# BULLETIN # 0 2

**PROJECT:** Harrison Recreation & Community Center – PHASE 2  
Harrison, NY

**RE:** Geotechnical Revisions

Re: Recommendations following 2-4-2025 Field Visit  
Harrison Recreation Center, 270 Harrison Avenue  
Harrison, NY

Sheet Title	Job No.	Sheet No.
BASEMENT DRAINAGE	2020-1005	ASK-2
	Date	
S.E.D. Control No.	1/24/2025	Reference Drawing:
	Scale	
	1/16" = 1'-0"

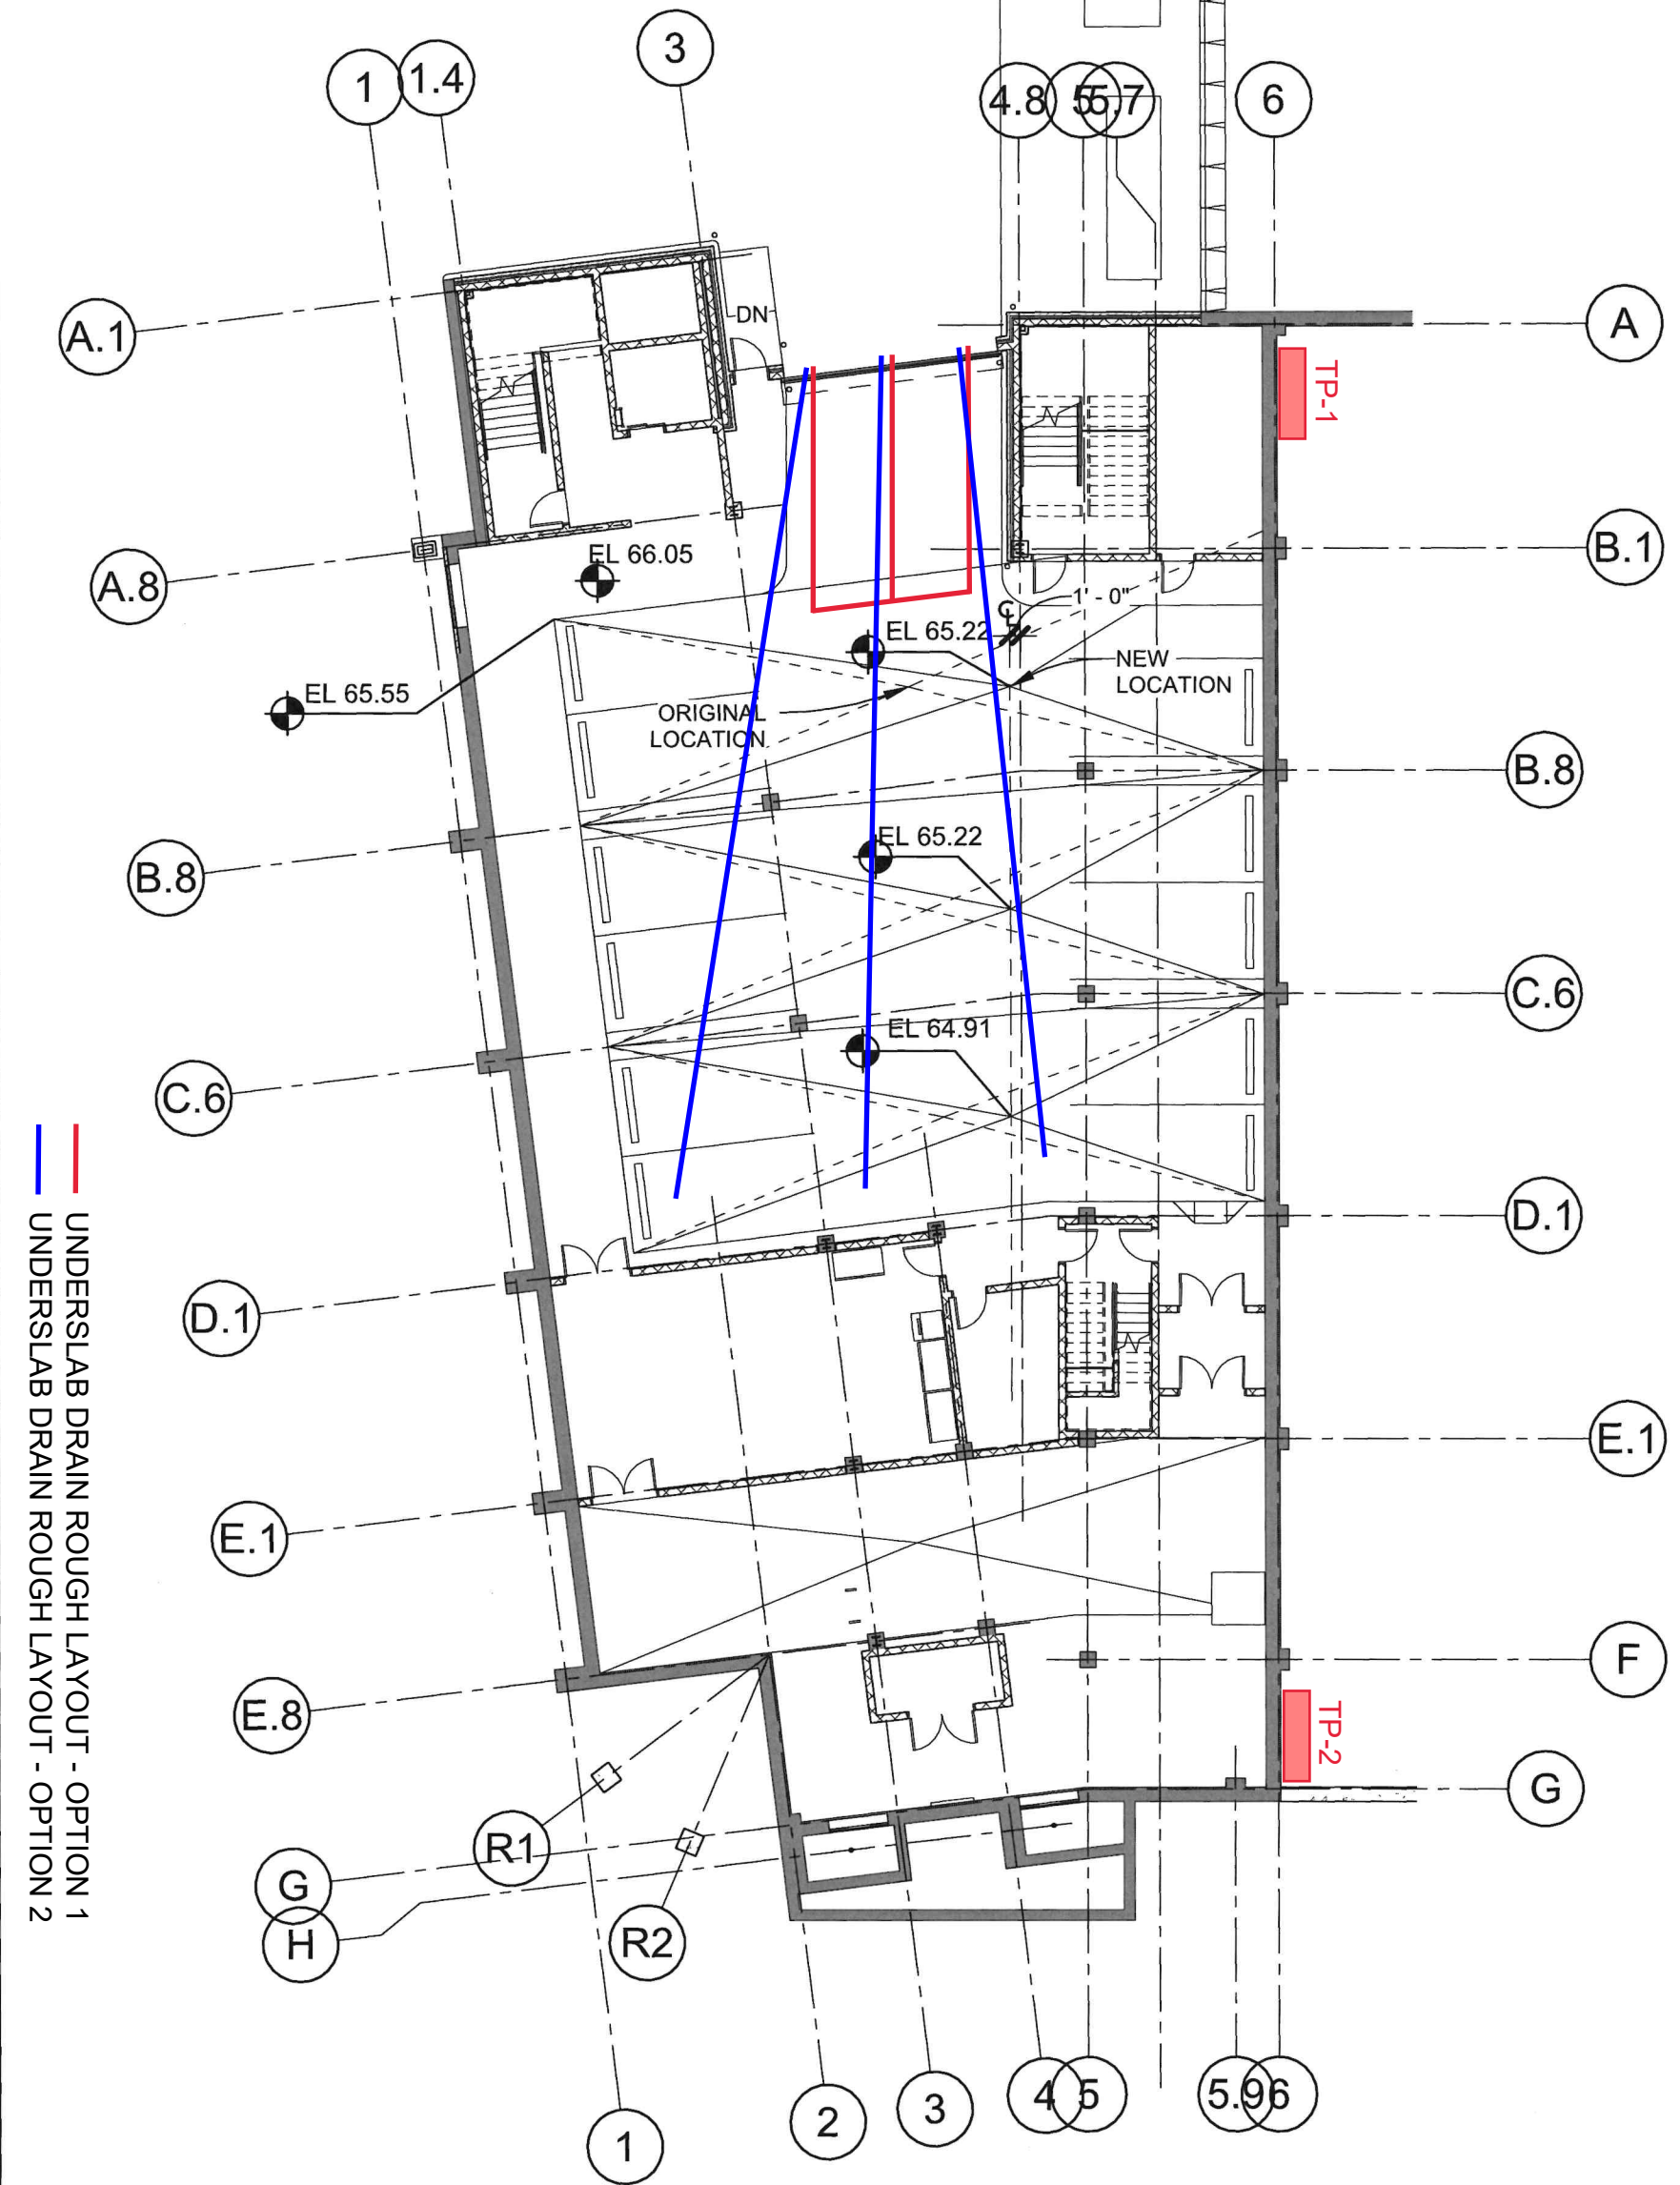
The attached ASK-02 illustrates the revised under slab drainage configuration. Please proceed with Option 2 as shown on ASK-02. The attached letter provides descriptions of the materials.

We reviewed the current conditions in the garage area and discussed the slab being raised here approximately 1 ft. Considering the amount of underground utilities that need to fit within the stone layer below the slab, and the fact that the stone itself will act as a suitable conduit for groundwater removal, we are revising our previous recommendations to greatly reduce the number and extent of the underslab drain pipe network. We now recommend three (3) drain pipes be installed through the side wall of the trench drain at the garage entrance and either be connected in manifold-formation 10 ft. to 20 ft. into the garage (as space allows), or be splayed into the garage area (as space allows) and dead-ended. The attached sketch illustrates these options. These pipes should be as previously recommended - rigid, 2-hole perforated, smoothwall PVC pipe, either 3 in. or 4 in. diameter (ex. Charlotte PVC 30030P or PVC 30040P, or similar), with the two (2) holes centered facing downward, and be placed level or at a slight pitch towards the trench drain and enclosed in a filter fabric sock.

Lastly, we observed the excavation of two (2) test pits behind (to the north of) the 6-line. Test pit TP-1 was performed along the westernmost  $\pm 8$  ft. of the wall, while test pit TP-2 was performed along the easternmost  $\pm 10$  ft. of the wall, and both pits were excavated to a depth of  $\pm 4$  ft. The small excavator seemed to dig both test pits with relative ease, i.e. it did not struggle at all to penetrate the soils. Both test pits revealed the wall was backfilled with on-site soils along with cobbles ranging in size up to 8 in. to 10 in. diameter at TP-1, and up to 12 in. diameter at TP-2. The soils were very moist and a hand probe penetrated 6 in. to 8 in. vertically into the bottom and 8 in. to 10 in. horizontally into the sidewall of TP-1 at various locations, and 8 in. to 12 in. deep in the bottom of TP-2. Cobbles were observed in contact with the back of the retaining wall and also nested together.

1. BASE PLAN ALTERED BY EUGENE J. SCHWARZROCK, P.E. 0077007-1 OF SKYLANDS ENGINEERING, LLC, 124 MILTON ROAD, SPARTA, NJ 07871, CERTIFICATE OF AUTHORIZATION NO. 0013524 ON FEB. 5, 2025 TO SHOW TEST PIT LOCATIONS AND UNDERSLAB DRAIN OPTIONS
2. REVISIONS SHOWN IN RED AND BLUE
3. BASE PLAN PROVIDED BY KG+D
4. OPTION 1- ONLY IF CONFLICTS ARE ENCOUNTERED WITH OPTION 2
